Access Compliance Report

Public Rights-of-Way

(Curb Ramps)

Intersection ID: 31281	Main Street: MALLARD_GLEN_DR	Cross Street: WESTBEND_DR	Location: SW
ADA ID: 835CB0F75BBA	Ramp Type: PerpDiag	Initial Pass/Fail: Fail	Overall Compliance: No
		Severity Score: 30

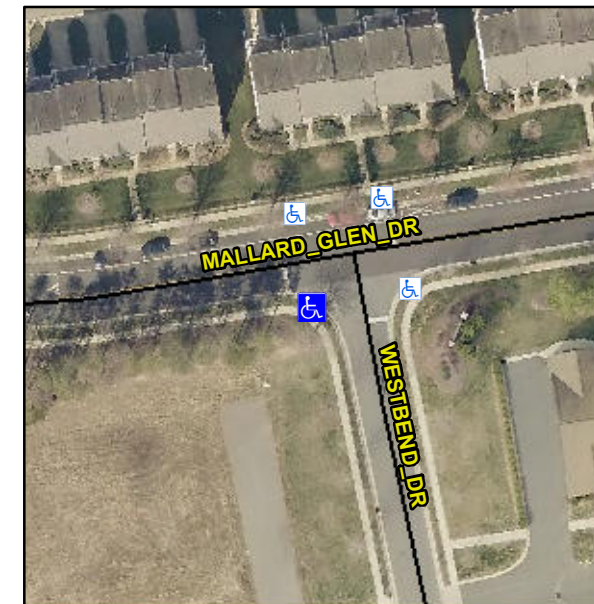
R304.5.1, R304.2.2

Compliance	Description	Data	Compliance	Description	Data
N/A	Ramp Length (in)	110.0	No	Ramp Slope (%)	9.5
No	Ramp Width (in)	34.0	Yes	Ramp XSlope (%)	1.3
N/A	Flare Type LT	N/A	N/A	Flare Type RT	N/A
N/A	Flare Slope LT (%)	N/A	N/A	Flare Slope RT (%)	N/A
N/A	Flare Traversable LT?	N/A	N/A	Flare Traversable RT?	N/A
N/A	Landing Length (in)	N/A	N/A	DWS Provided?	N/A
N/A	Landing Width (in)	N/A	N/A	DWS Contrast?	N/A
N/A	Landing Slope (%)	N/A	N/A	DWS Length (in)	N/A
N/A	Landing X Slope (%)	N/A	N/A	DWS Full Width?	N/A
N/A	Landing Curb? (Y/N)	N/A	N/A	DWS Offset (in)	N/A
N/A	Shared Landing?	N/A			
N/A	Gutter Ponding?	N/A	N/A	Gutter Slope (%)	N/A
N/A	Gutter Lip Ht (in)	N/A	N/A	Gutter X Slope (%)	N/A
N/A	Painted X Walk1?	No	N/A	Painted X Walk2?	No
	X Walk 1 Direction	To E		X Walk 2 Direction	To N
N/A	X Walk 1 Width (in)	N/A	N/A	X Walk 2 Width (in)	N/A
	X Walk 1 Slope (%)	0.3		X Walk 2 Slope (%)	4.0
	X Walk 1 X Slope (%)	3.3		X Walk 2 X Slope (%)	0.2

Remove & Replace Curb Ramp With Two New Directional Ramps or Equivalent.
